Access Compliance Report

Public Rights-of-Way

Intersection ID: 29679	Main Street: CAMERON_CREEK_DR	Cross Street: SANDY_RIDGE_LN	Location: W
ADA ID: 5D244C602AEF	Ramp Type: PerpDiag	Initial Pass/Fail: Fail	Overall Compliance: No
			Severity Score: 21.25

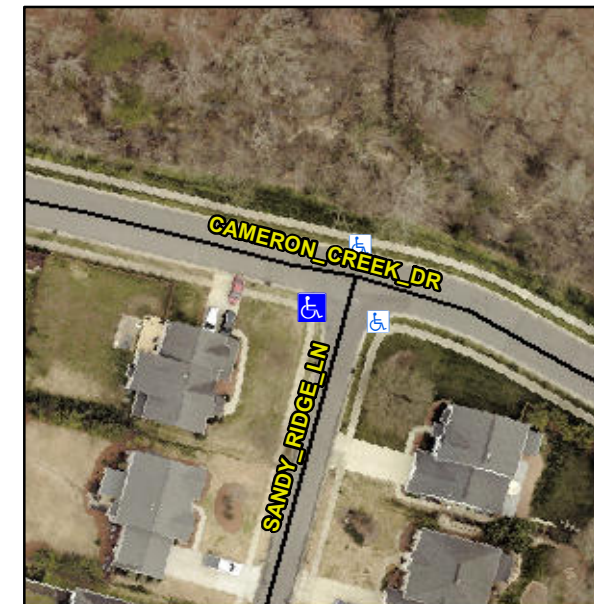
Not Found, R304.5.1, R304.2.2

Compliance	Description	Data	Compliance	Description	Data
N/A	Ramp Length (in)	42.0	No	Ramp Slope (%)	10.1
No	Ramp Width (in)	43.5	Yes	Ramp XSlope (%)	1.6
N/A	Flare Type LT	N/A	N/A	Flare Type RT	N/A
N/A	Flare Slope LT (%)	N/A	N/A	Flare Slope RT (%)	N/A
N/A	Flare Traversable LT?	N/A	N/A	Flare Traversable RT?	N/A
N/A	Landing Length (in)	N/A	N/A	DWS Provided?	N/A
N/A	Landing Width (in)	N/A	N/A	DWS Contrast?	N/A
N/A	Landing Slope (%)	N/A	N/A	DWS Length (in)	N/A
N/A	Landing X Slope (%)	N/A	N/A	DWS Full Width?	N/A
N/A	Landing Curb? (Y/N)	N/A	N/A	DWS Offset (in)	N/A
N/A	Shared Landing?	N/A			
N/A	Gutter Ponding?	N/A	N/A	Gutter Slope (%)	N/A
N/A	Gutter Lip Ht (in)	N/A	N/A	Gutter X Slope (%)	N/A
N/A	Painted X Walk1?	No	N/A	Painted X Walk2?	No
	X Walk 1 Direction	To SE		X Walk 2 Direction	To NE
N/A	X Walk 1 Width (in)	N/A	N/A	X Walk 2 Width (in)	N/A
	X Walk 1 Slope (%)	1.5		X Walk 2 Slope (%)	4.2
	X Walk 1 X Slope (%)	0.9		X Walk 2 X Slope (%)	1.8

Remove & Replace Curb Ramp With Two New Directional Ramps or Equivalent.
